In accordance with the provisions of Section 320-21 (11) and (12) of the Milwaukee Code of Ordinances, the Milwaukee Historic Preservation Commission has issued a certificate of appropriateness for the work listed above. The work was found to be consistent with preservation guidelines. The following conditions apply to this certificate of appropriateness:

City of Milwaukee Historic Preservation Staff

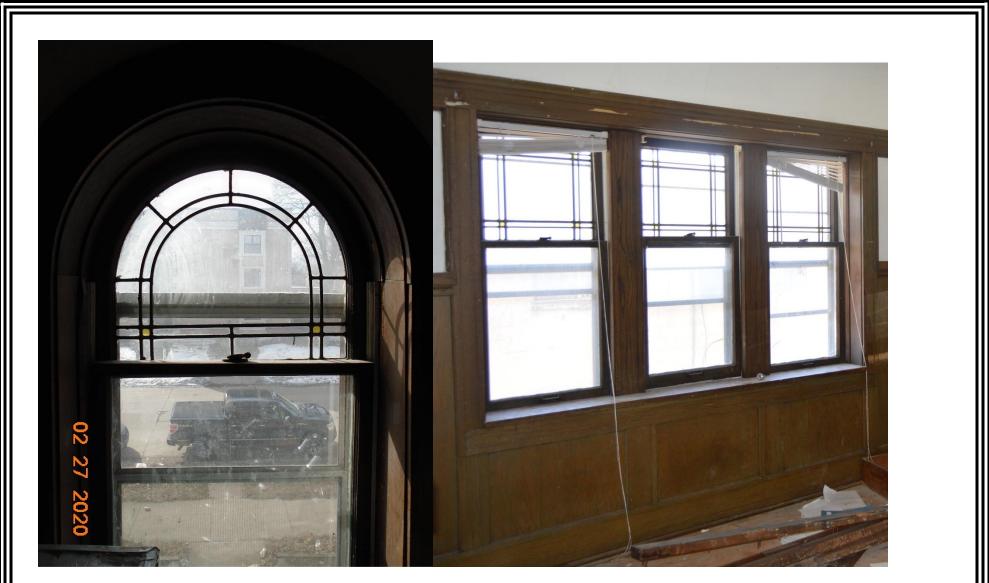
Approved replicated window sash with non-lead caming.

Sahara #1 at top. Sahara #2 at bottom.

LEFT: Typical original casement window fore replication along with mortar color.

Typical leaded glass window with the small stained glass components. Rectangular sash come in two different sizes. Round-top sash exist only in the one size shown.

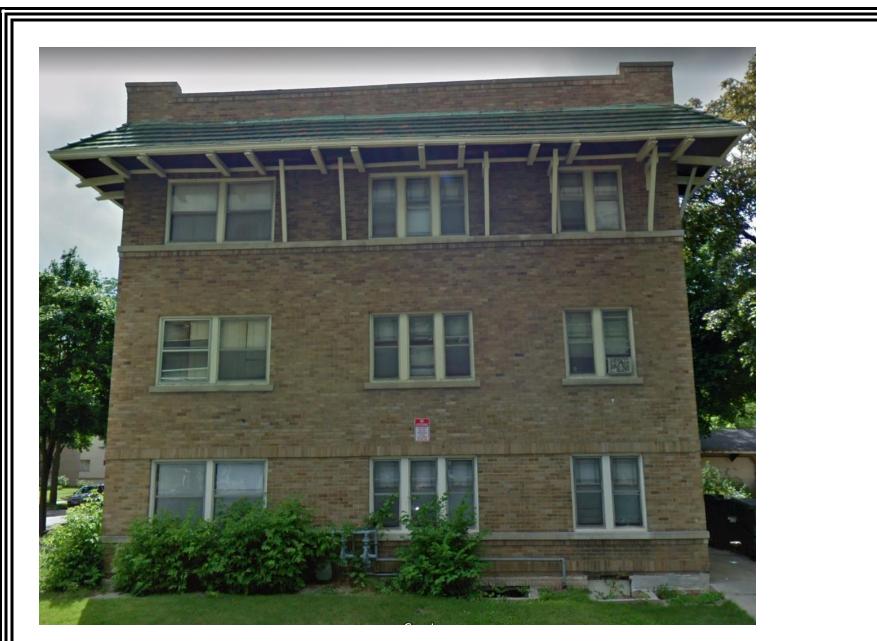
2011 photo showing location of all stained glass windows on front. All must be restored. Outside corner windows were leaded casement with no stained glass. See plans on later pages.
